DSP-99044-07

Application	General Data	
Project Name: Prince George's Plaza, Parcel A-1 Chick-fil-A Location: Located at the northeastern quadrant of the intersection of East-West Highway (MD 410) and Belcrest Road. Applicant/Address: Chick-fil-A 5200 Buffington Road Atlanta, GA 30349	Planning Board Hearing Date:	10/31/13
	Staff Report Date:	10/16/13
	Date Accepted:	08/29/12
	Planning Board Action Limit:	Waived
	Plan Acreage:	51.03
	Zone:	C-S-C/T-D-O
	Dwelling Units:	N/A
	Gross Floor Area:	5,030 sq. ft.
	Planning Area:	68
	Tier:	Developed
	Council District:	02
	Election District:	17
	Municipality:	Hyattsville
200-Scale Base Map:	208NE03

SUBJECT: Detailed Site Plan DSP-99044-07
Prince George's Plaza, Chick-fil-A

1 STREET ELEVATION
3/16" = 1'-0"

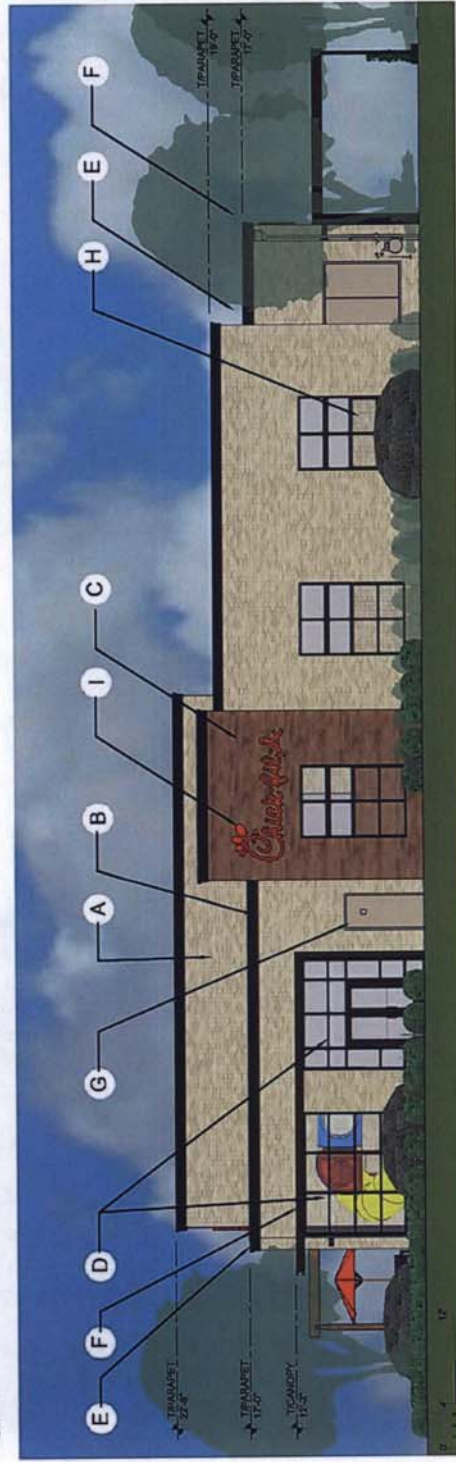
The windows propose multiple panes of glass. Metal green screen frames are proposed to be mounted below the windows along the East-West Highway and parking lot elevations to allow for climbing plants. Along the East-West Highway elevation, some improvements to the fenestration appear warranted. The three equally-sized windows proposed along this elevation appear small

and inconsequential with too much space in between. Modifications of the fenestration, including larger windows with less space in between each, would give this elevation the additional visual prominence that is warranted along East-West Highway.

Comment: Staff believes that the sense of arrival on the southern façade, facing East-West Highway, would be improved with a more balanced fenestration and an enhanced window treatment to give this elevation the prominence that is warranted due to its highly visible location.

- (1) Revise the south building elevation facing East-West Highway to improve the appearance by enlarging the windows and reducing the space in between each window.

2 DRIVE-THROUGH ELEVATION
3/16" = 1'-0"

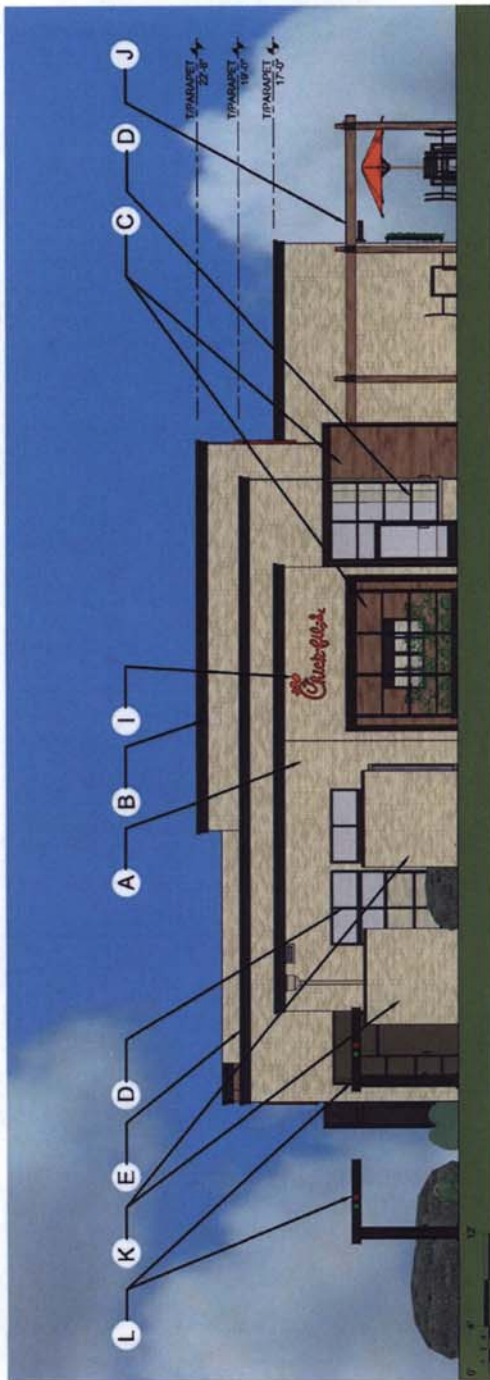
Drive-Through Service Window—The planned configuration of the drive-through service queuing and departure areas ensures direct pedestrian access to the proposed restaurant from the streetscape and eliminates a previously proposed drive-through form that would have wrapped the building with paved loading and queuing areas. This new configuration represents a significantly improved approach over the initial layout of the proposed development. However, the drive-through component by its very nature is contrary to the goals for the Prince George's Plaza Transit District. It is not a transit oriented form of development and is designed to accommodate the automobile. The proposed drive-through and double queuing lanes are located directly adjacent to the pedestrian zone along East-West Highway. While a low wall would exist between the drive through and the pedestrian zone, vehicle exhaust and lighting associated with drive-through and queuing lane would provide negative impacts to the pedestrian realm. Queuing lanes for the drive-through begin 12 feet from the existing sidewalk. For this reason and the overall goals of the TDDP, staff recommends the removal of the drive-through feature.

1. Prior to signature approval of the plans, the applicant shall revise the detailed site plan or provide additional information as follows:
 - a. Revise the plan to remove the drive-through service window, vehicular lanes and all other plan elements associated with the feature and convert the area into parking, green space, and/or amenity space.
